STATEMENT OF DEFICIENCIES AND PLAN OF CORRECTION		(X1) PROVIDER/SUPPLIER/CLIA IDENTIFICATION NUMBER: 205105	(X2) MULTIPLE CONSTRUCTION A. BUILDING 01 B. WING _____		FEB 16 2024 BY: _____	(X3) DATE SURVEY COMPLETED 01/30/2024
NAME OF PROVIDER OR SUPPLIER WESTGATE CENTER FOR REHAB & ALZHEIMERS CARE			STREET ADDRESS, CITY, STATE, ZIP CODE 750 UNION ST BANGOR, ME 04401			
(X4) ID PREFIX TAG	SUMMARY STATEMENT OF DEFICIENCIES (EACH DEFICIENCY MUST BE PRECEDED BY FULL REGULATORY OR LSC IDENTIFYING INFORMATION)	ID PREFIX TAG	PROVIDER'S PLAN OF CORRECTION (EACH CORRECTIVE ACTION SHOULD BE CROSS-REFERENCED TO THE APPROPRIATE DEFICIENCY)		(X5) COMPLETION DATE	
E 000	Initial Comments Federal Recertification Survey Survey Date 1/30/2024 Westgate Center for Rehab & Alzheimers Care, a long term care facility, is in substantial compliance with 42 Code of Federal Regulations Part 483.73 Requirement for Long Term Care Facilities Emergency Preparedness.	E 000

Plan of Correction for Life Safety Inspection Conducted on 1/31/24

**SUITES &
SMOKE COMPARTMENTS**

RE: Westgate Center for Rehabilitation and Alzheimer's Care

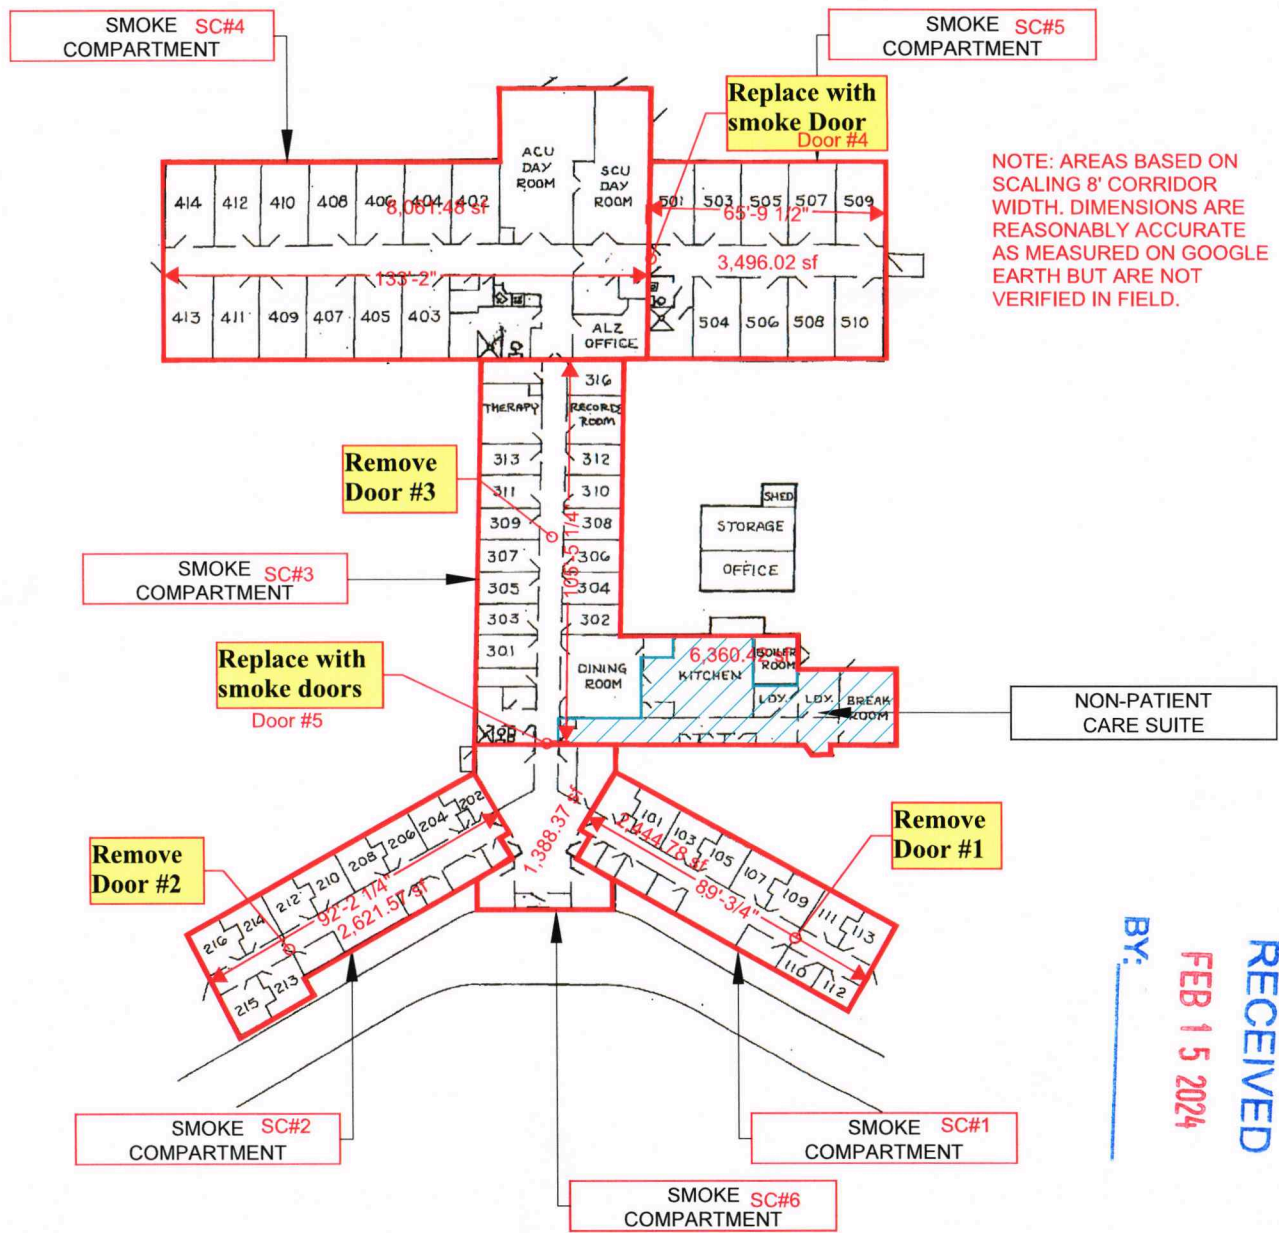
Gawron Turgeon Architects has reviewed the deficiencies noted in the Statement of Deficiencies issued on January 30, 2024 to The Westgate Center for Rehabilitation and Alzheimer's Care. The deficiencies, noted with tag K761, include 4 doors that are indicated to have a 90-minute rating. These doors lack required latching at the floor due to replacement flooring which has obscured the strike plate. An additional pair of doors was found to have a meeting gap in excess of 1/8".

To correct the deficiencies, we are proposing the removal of (3) doors indicated to have a 90-minute rating where the 90-minute rating is not required:

Door #1 is a cross-corridor door within Smoke Compartment 1. It does not address any requirements of the code. Removal of this door does not change the Life Safety features of the building.

Door #2 is a cross-corridor door within Smoke Compartment 2. It does not address any requirements of the code. Removal of this door does not change the Life Safety features of the building.

Door #3 is a cross-corridor door within Smoke Compartment 3. It does not address any requirements of the code. Removal of this door does not change the Life Safety features of the building.

Further, we are proposing to replace (2) existing doors that have ratings and/or hardware that is inconsistent with the appropriate ratings and hardware for a door in a smoke barrier:

Door #4 is within the smoke barrier separating Smoke Compartments 4 and 5. Door #5 is within the smoke barrier separating Smoke Compartments 3 and 6. Per 2018 NFPA 19.3.7.8, these doors shall be self-closing and are not required to be latching. We are proposing to replace the existing (2) doors with unlabeled doors equipped with closers. These doors will have no latching hardware.

We believe that the above corrective actions will bring the facility into compliance.
